## **BUTTE-SILVER BOW ZONING BOARD OF ADJUSTMENT**

**Thursday, June 23, 2016, at *5:30 P.M.*  
Council Chambers – Third Floor – Room 312**

**BUTTE-SILVER BOW  
ZONING BOARD OF ADJUSTMENT  
STAFF ANALYSIS**

**BUTTE-SILVER BOW  
ZONING BOARD OF ADJUSTMENT  
STAFF ANALYSIS**

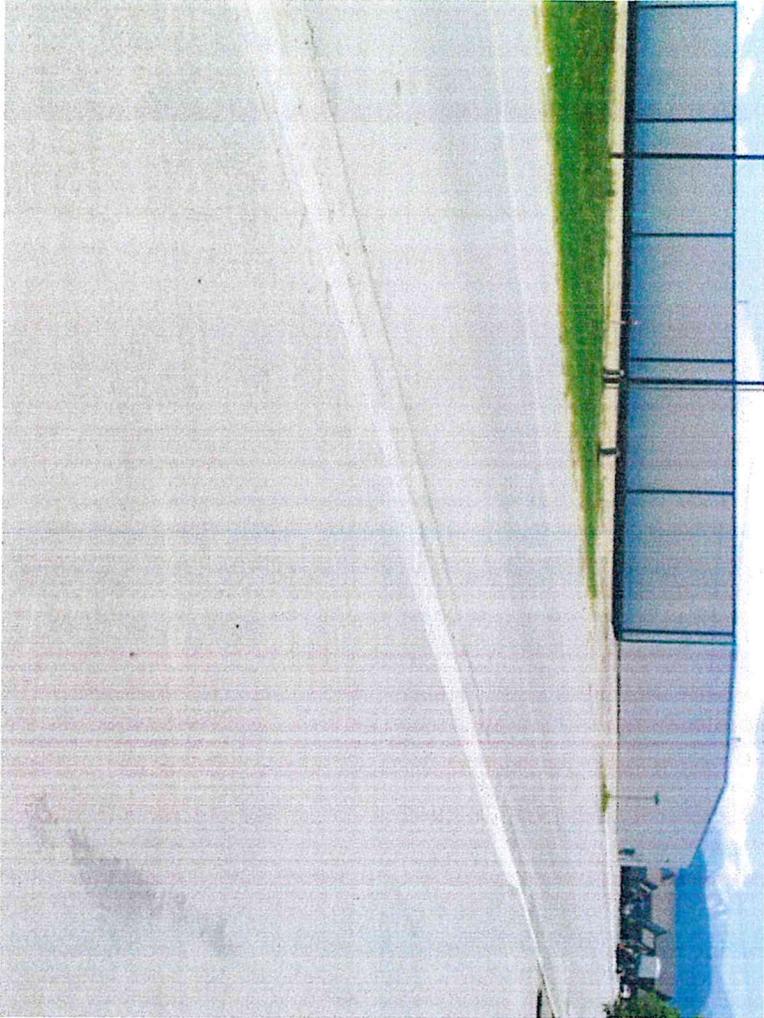
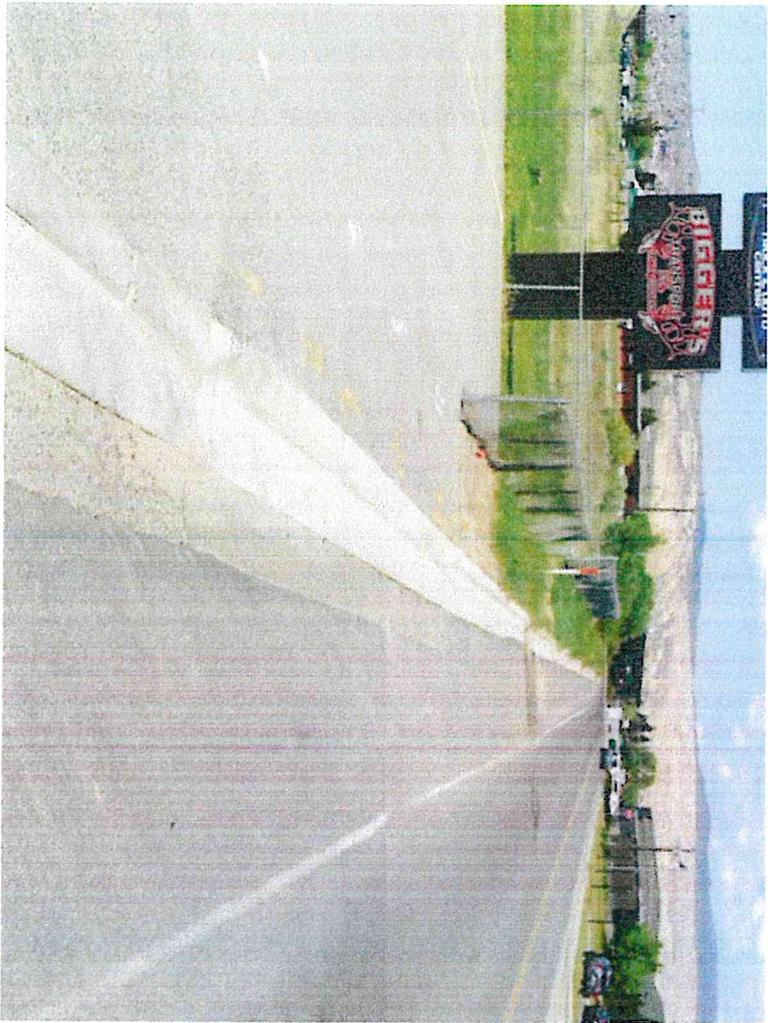
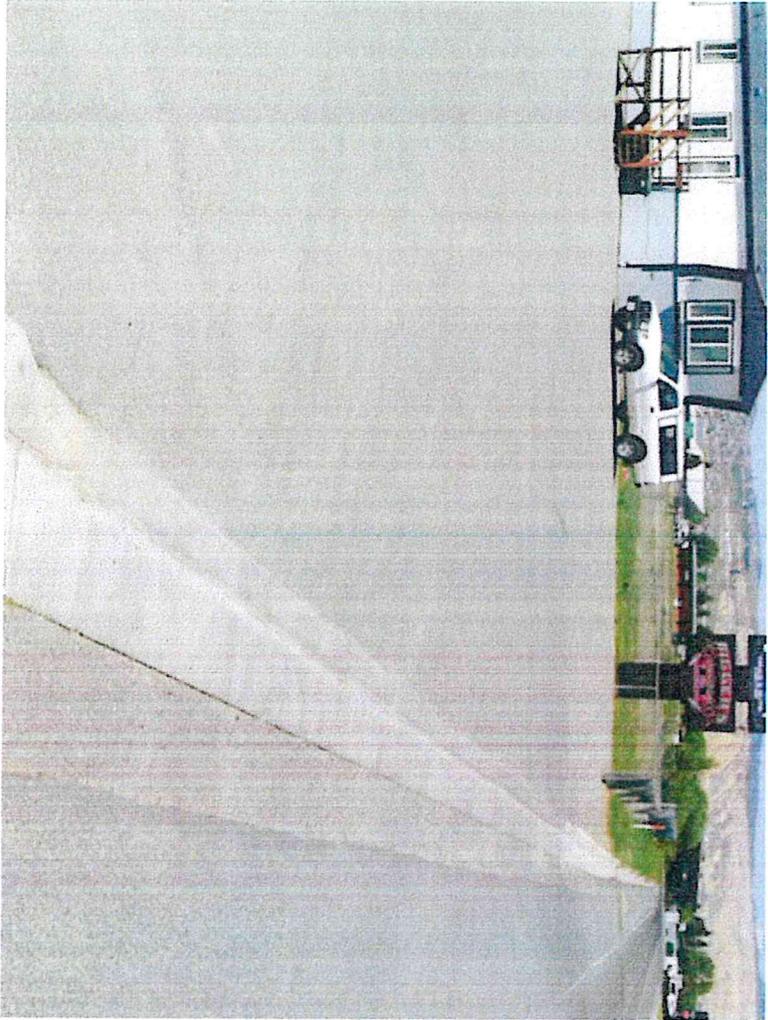
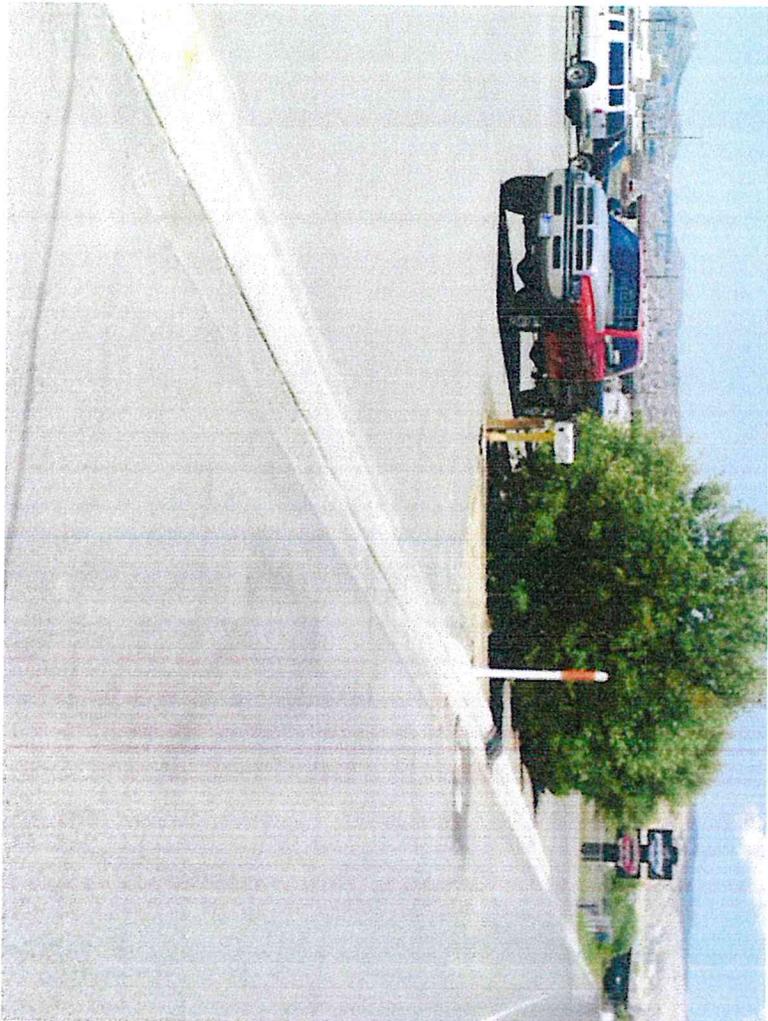
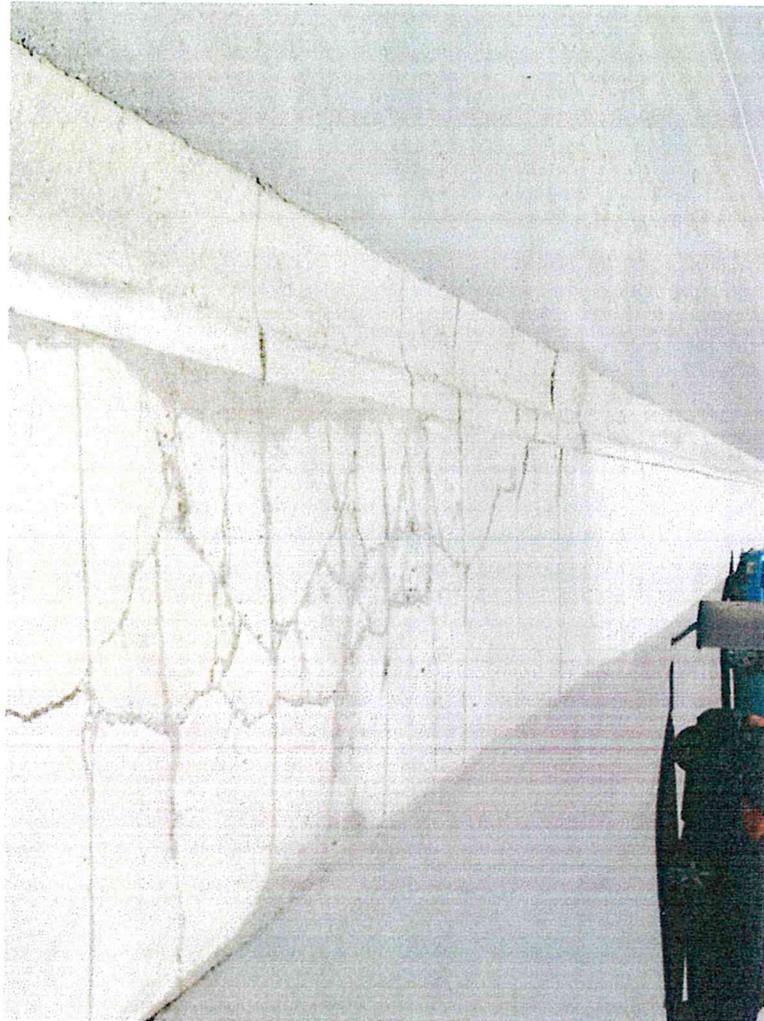
Whereas the property does not exhibit any unique physical conditions that would result in unnecessary hardship, it must be noted that the concrete approaches at the adjacent property along Wynne Avenue show significant cracking and degradation due to consistent heavy truck traffic. (Please see

attached photos submitted by the applicants.) This is technically a condition caused by the nature of the applicants' business and does not necessarily constitute a hardship, however, requiring constant repairing of the applicants' approaches based on a material specifications may cause undue hassle and incur unnecessary cost.

Site Plan

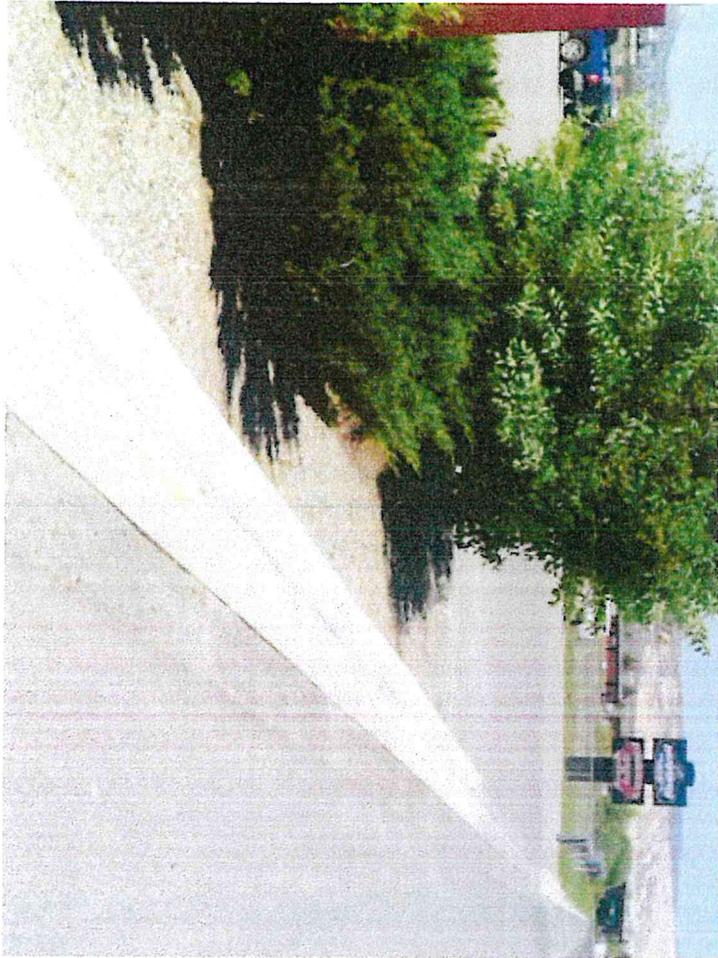
It should be noted, curb and gutter are already present on the property, and the applicants intend to install the majority of the concrete sidewalks required by Section 17.38.050. The only areas that they wish not to install the required concrete sidewalks are within the two driveway approaches adjacent to Wynne Avenue. The applicants are requesting these two exclusions because the two approaches were recently reconstructed in October of 2012 with asphalt material. Asphalt is more durable than concrete with respect to repetitive heavy truck traffic, and, as Biggers Transport has a continuous flow of heavy truck traffic, the applicants feel as though the installation of concrete sidewalks will not hold up under the continuous truck traffic that utilizes the facility. The concrete would break down under the weight of the trucks and be in need of constant repair to provide a safe walkable passage way.

The primary concern with respect to not installing concrete sidewalks along the applicants' driveway approaches would be compromising safe pedestrian passage in front of the industrial property, and neglecting to ensure ADA compliance along routes of pedestrian travel. In that regard, the applicants could provide striping to indicate to both vehicular traffic and pedestrians that a portion of the driveway approach is also utilized as the walking path to connect to the concrete sidewalks. In addition, the asphalt walkway will need to be ADA compliant. In that regard, the applicants will need to verify that the walkway area does not exceed a 2% cross slope. If the applicants are agreeable to ensuring ADA compliance and striping the asphalt to indicate it is a walkway across the two approaches, then the requested variance may not be contrary to the public interest.

1. Prior to the issuance of a building permit, the applicants must submit a detailed site plan to the Planning Department staff for review and approval. The site plan shall include a sidewalk, curb and gutter and paving details that illustrate compatibility between the new sidewalk installation and the existing asphalt approaches.

At a minimum, the plan shall include striping of the asphalt walkway traversing the approach and provide enough detail to determine that the new sidewalk, transition between the sidewalk and asphalt, and the asphalt walkway will be in compliance with all ADA requirements.

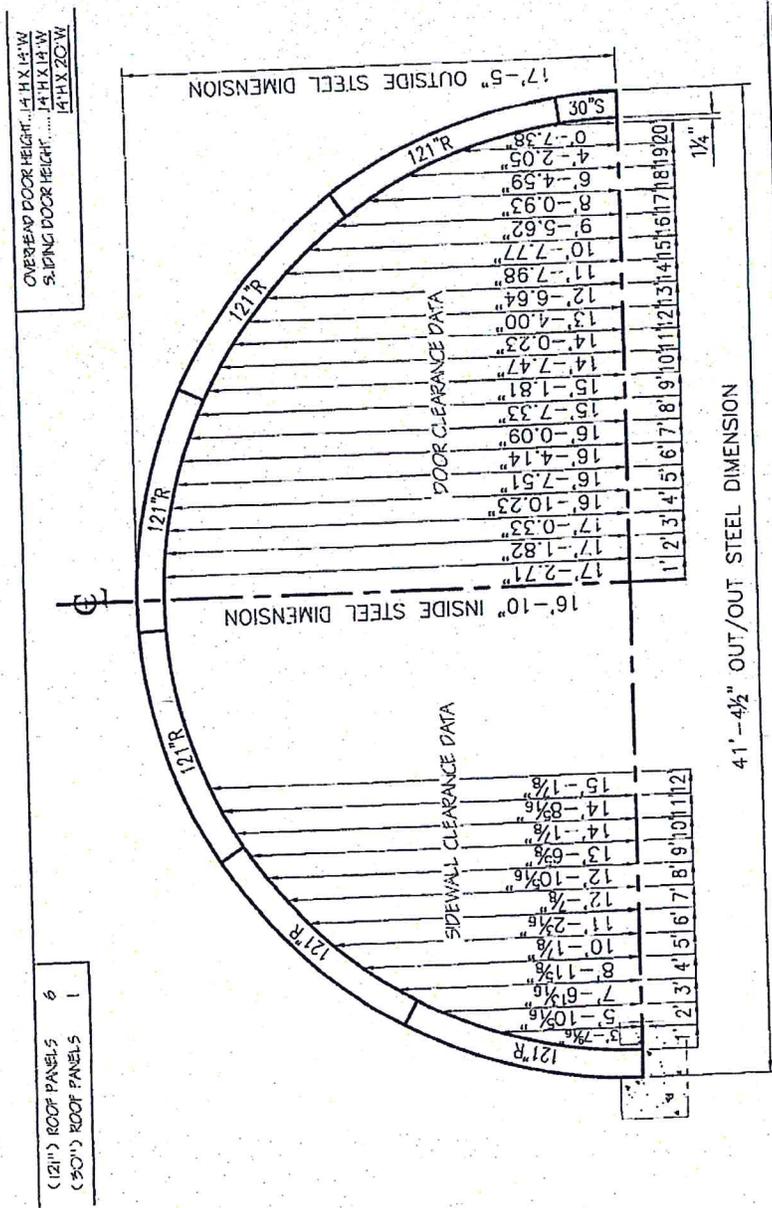
As previously stated, the applicants are requesting to build a (42'W X 42D') detached Quonset structure that would be seventeen feet (17') in height at the crown of the arc. While the size of the proposed structure is considerably larger than the typical residential garage, larger parcels of record do provide enough square footage that large detached structures can be constructed without exceeding the maximum permitted lot coverage of 35 percent.

In regards to the visual impact of the proposed garage, the height of the garage would be at least as tall as all of the neighboring properties, except the Waterford complex that is to the south of the applicants' property. Given that, the applicants' property is bordered on the east by Continental Drive and the proposed building site is set approximately six feet (6') below the elevation of the road and that of the residential properties on the east side of Continental Drive. Therefore, the majority of the visual impact from the proposed Quonset structure would be within the applicants' immediate block, bounded by East Lake Drive, Continental Drive and Willoughby Avenue. In that regard, the closest neighbor to the south of the proposed Quonset structure is the applicants' mother. The neighbors to the west across the alley are buffered by mature trees which should help mitigate any negative visual effects from the height of the Quonset. The property directly north of the applicants' property is vacant land.

Factors of concern are that the proposed Quonset structure is significantly larger in size than the typical residential detached garage and that Quonset structures are generally associated with industrial or agricultural uses, which may detract from the residential

1. Prior to receiving a building permit, the applicants will be required to provide documentation from the Montana Department of Revenue's Office stating the applicants' two properties have been combined into one legal parcel of record.
2. The Quonset structure shall abide by all other regulations of the BSBMC for "R-1" (Single

Family Residential) zones and shall at no time nor for any reason be utilized for any commercial uses.
